BROWNS FERRY NUCLEAR PLANT, UNIT 3

Amendment No. 70  
License No. DPR-68

ATTACHMENT TO LICENSE AMENDMENT NO. 70

SUPPORTING AMENDMENT NO. 70 TO FACILITY OPERATING LICENSE NO. DPR-68

Figure 3.5.K-1  
 MCPR Limits for 8x8R, P8x8R and LTAs

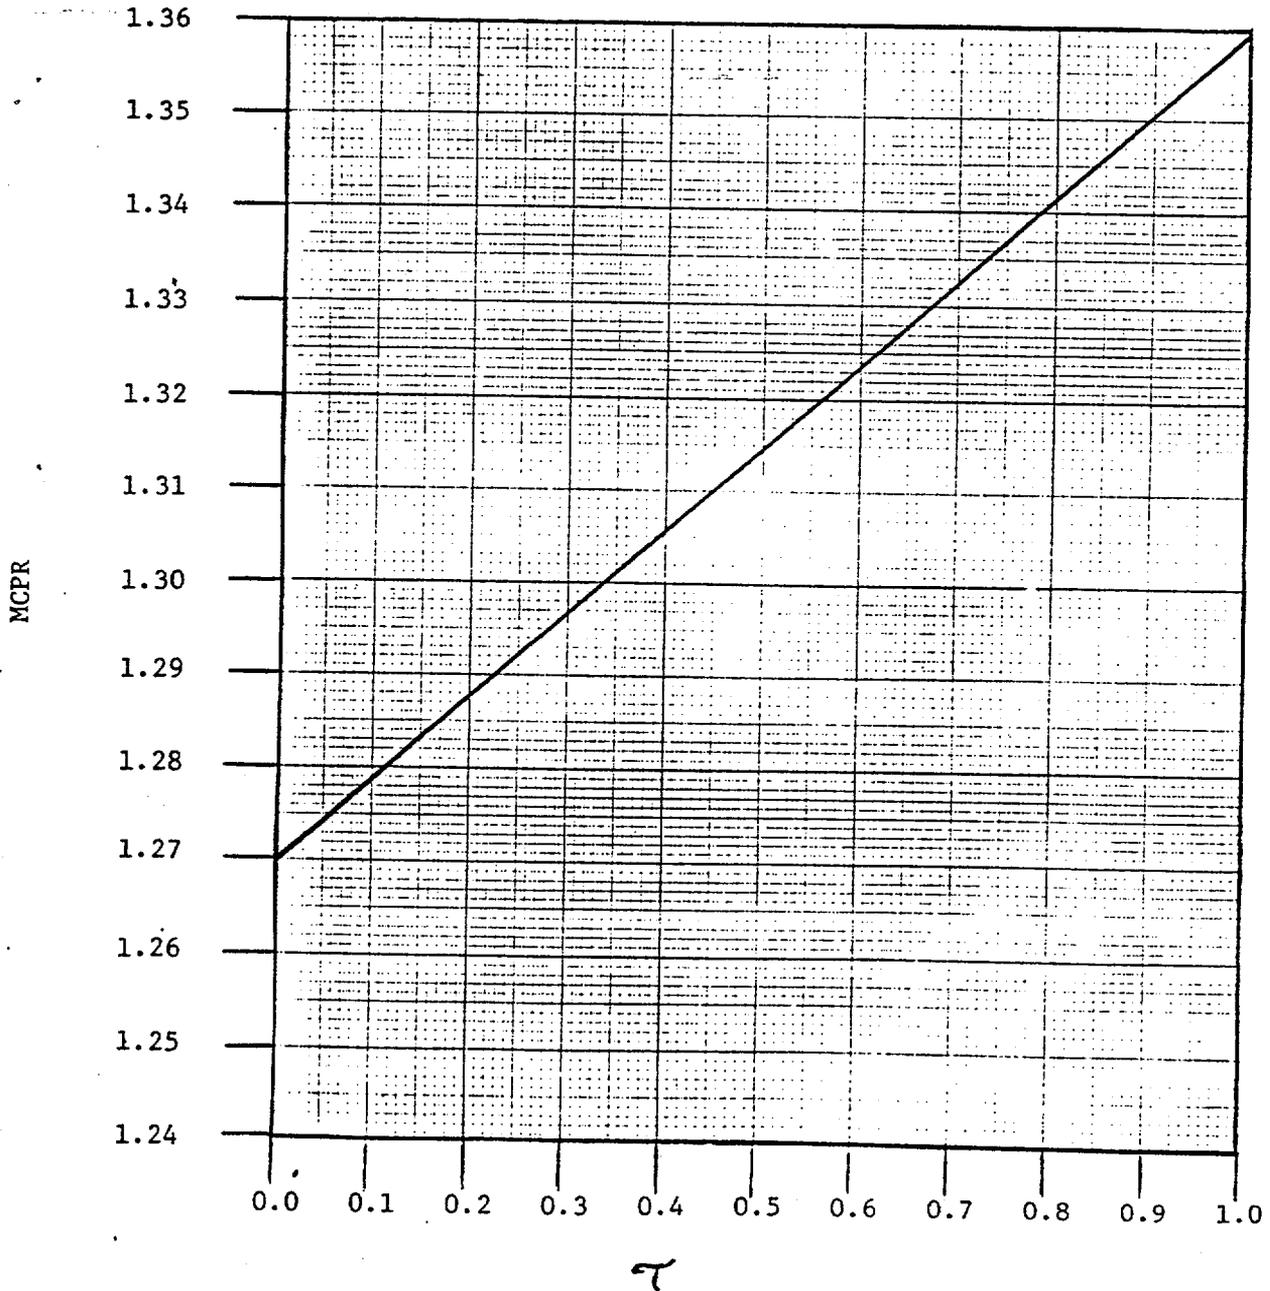
A curve of MCPR as a function of average scram insertion time has been updated for the Technical Specifications.

Specification 3.5.K will be changed to update MCPR limits for Cycle 6. The Table of Contents will be revised to reflect the new page number of Figure 3.5.K-1.
